6. Exploded View

Outdoor Unit

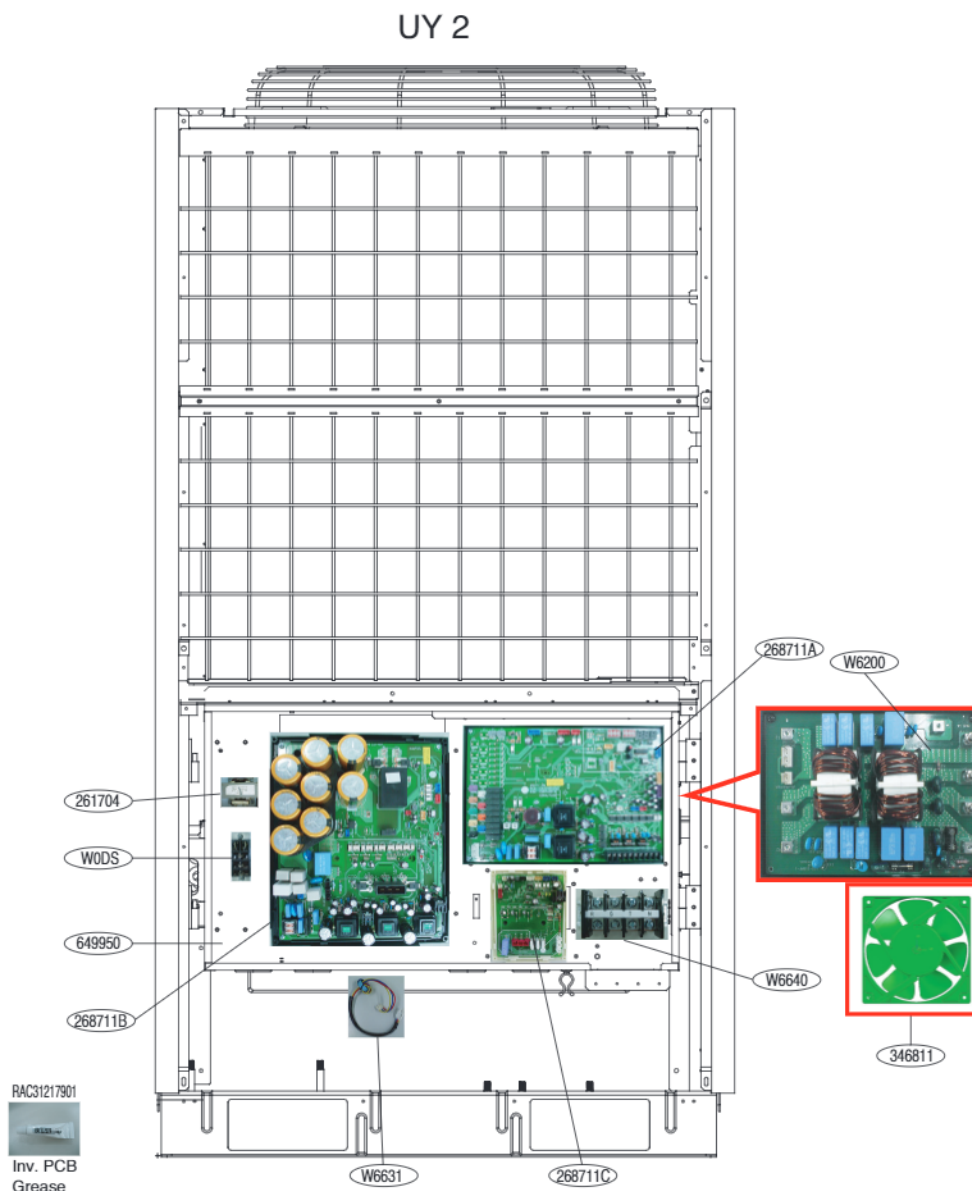
※ Before replacing INV control box or Fan motor PCB,
Please check Part Number.
There are two Part Number.

※ After May , 2010 , Multi V Plus II use LG motor (New).

- * Before replacing fan motor, Please check fan motor maker.
- * Panasonic Motor (Part Number : EAU43475201) is the obsolete part. Please replace Panasonic Fan Motor with LG Fan Motor (Part Number : EAU36301603) and LG Fan Motor PCB.
